ALERT SERVICE BULLETIN

NO. 407-09-88

MODEL AFFECTED: 407

SUBJECT: STAKED BEARINGS, ONE-TIME INSPECTION OF.

Figure 1. Affected part Supplier marking.

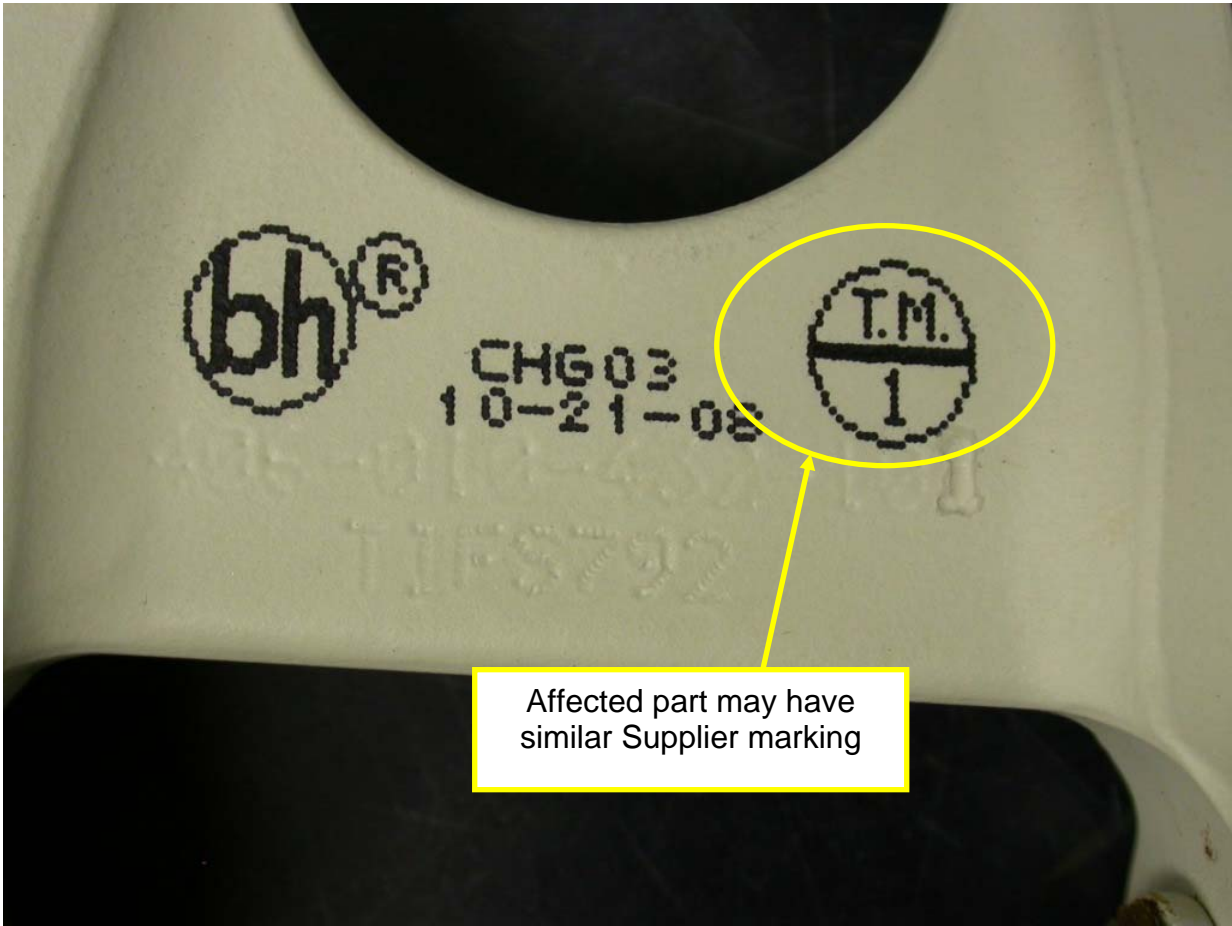
Bell Helicopter issues this bulletin to accomplish a one-time inspection of various parts that could potentially exhibit the same defect. The affected parts are separated in Table 1 and Table 2 based on installation characteristics and criticality. Parts in service and all spare parts are affected. When serialized, only parts with serial number prefix TI or TIFS are affected. However, affected part not serialized, may have Supplier marking as shown on Figure 1.
